1815 Montreal Road

Planning Rationale Addendum
Zoning By-law Amendment + Site Plan Control Application
October 6, 2025

October 2025

Figure 1: Truck turning template extracted from the TIA, showing an HSU truck reversing into the layby to exit the site, prepared by CGH Transportation

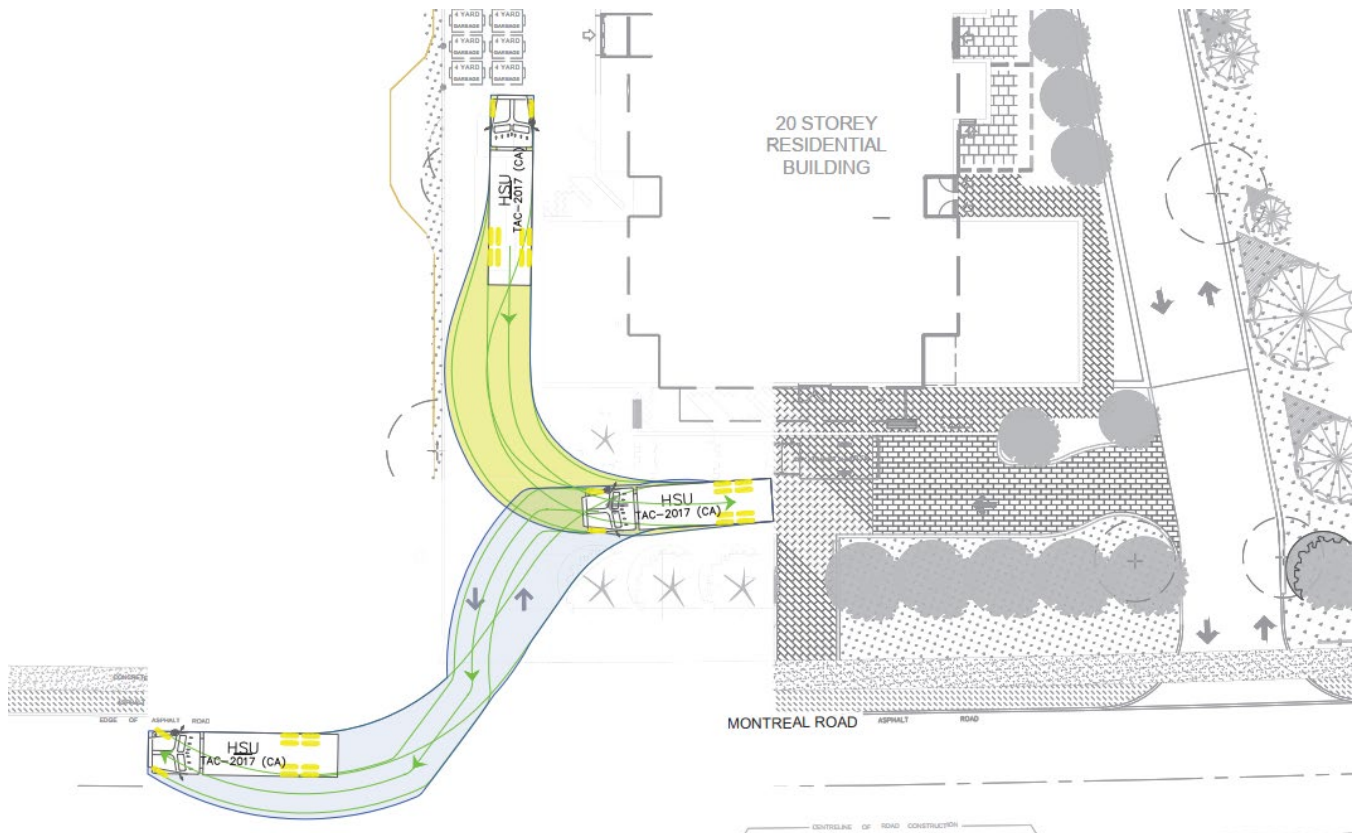
- / Widening of the servicing lane, from 4 to 6 metres, on the west side of the property to facilitate use by trucks and subsequent narrowing of the podium on the west side of the building;
 - Access to the bicycle room and move-in/ move-out room at-grade is maintained;
 - Heavy Single Unit (HSU) trucks will be able to reverse into the layby to turn around and exit the site rather than reversing onto Montreal Road, as shown in Figure 1, below:

Figure 6: Comparison of the angular plane measured from the property line of 201 Rothwell Circle to the east, comparing the previous submission (left) and the current resubmission (right)

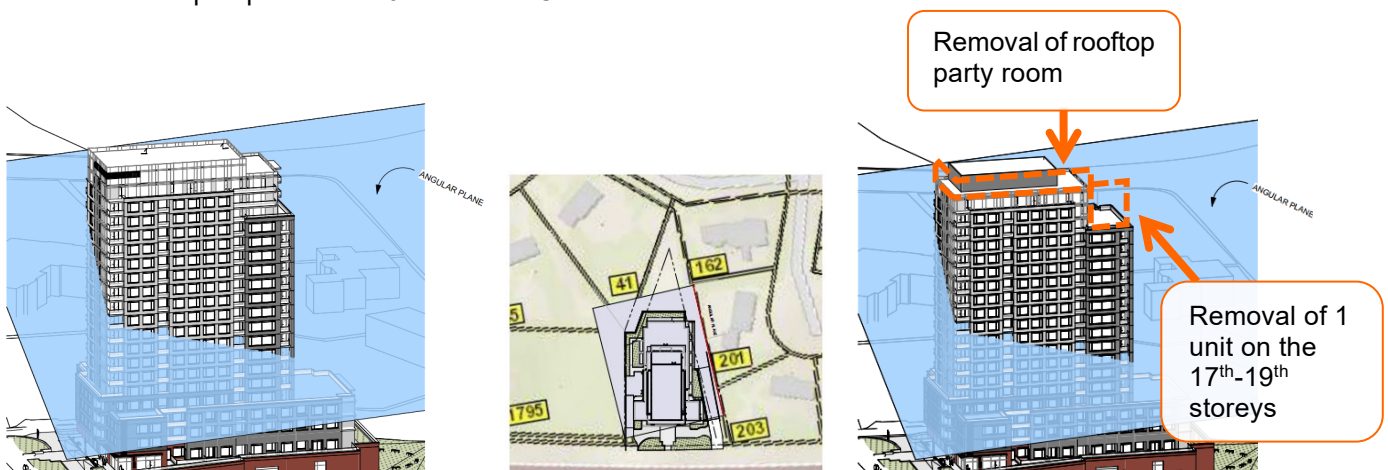
As shown in the angular plane diagrams below, the amount of the building projecting into the angular plane has been reduced from the perspective of 201 Rothwell Circle:

Figure 8: Comparison of the angular plane measured from the property line of 41 Cedar Road to the northwest, comparing the previous submission (left) and the current resubmission (right)

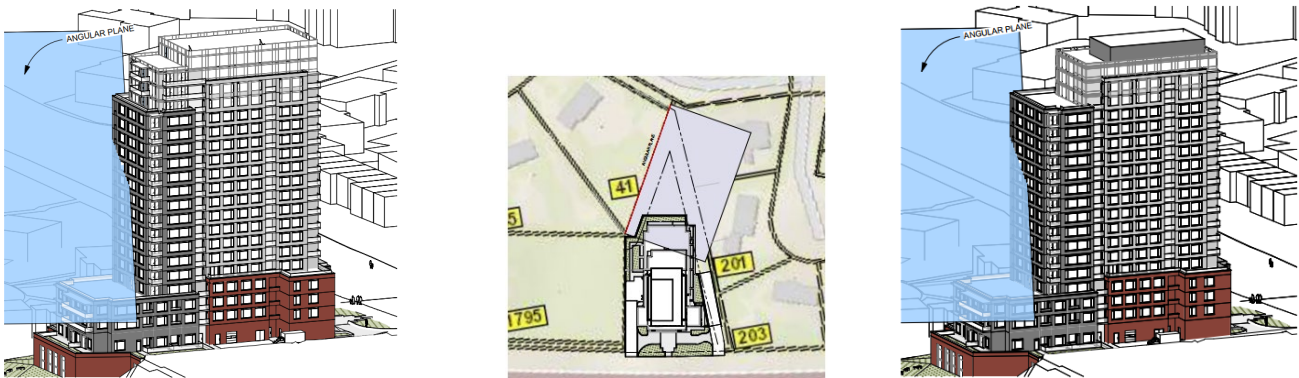
As with the previous submission, regardless of whether you measure the angular plane from the property line or the minimum required rear yard setback for 41 Cedar Road, the building only demonstrates a modest projection into the angular plane from 201 Rothwell Circle. This degree projection into the angular plane has been maintained with the present resubmission:

Figure 11: Screenshot of the Landscape Plan, prepared by GJA Inc.

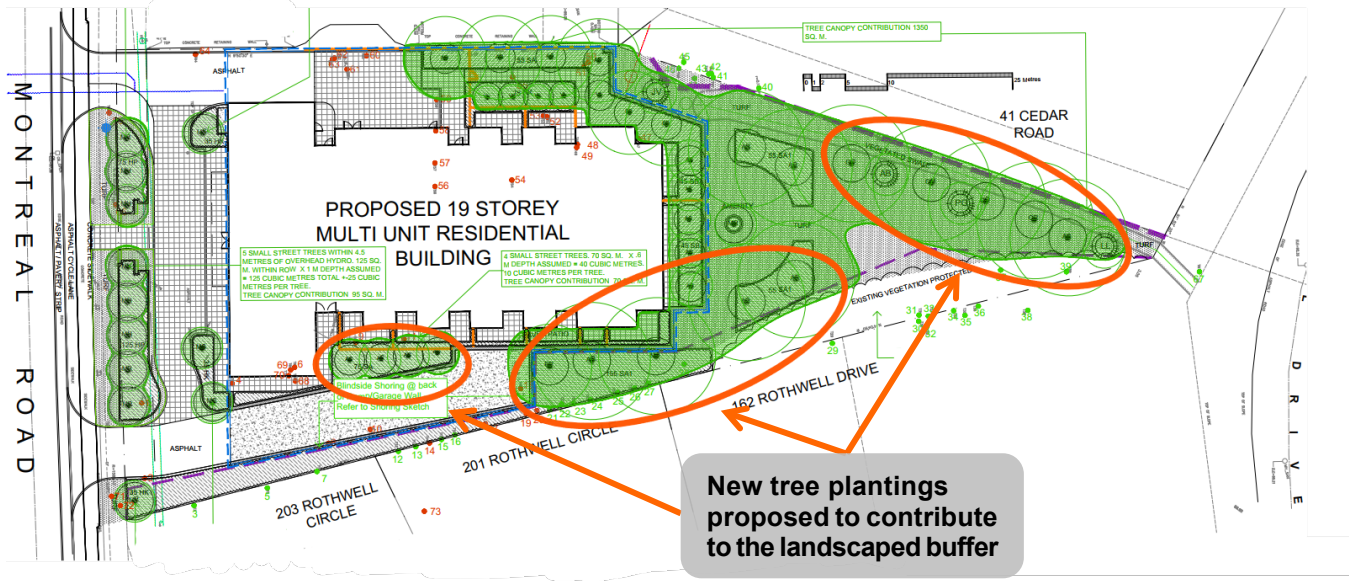
As shown in the Tree Conservation Report (TCR), many of these trees will be protected to maintain this buffer and expanded with additional native plantings. For instance, as shown on the Landscape Plan prepared by GJA Inc., multiple new tree plantings will contribute to the landscaped buffer, outlined in orange in Figure 10, below:
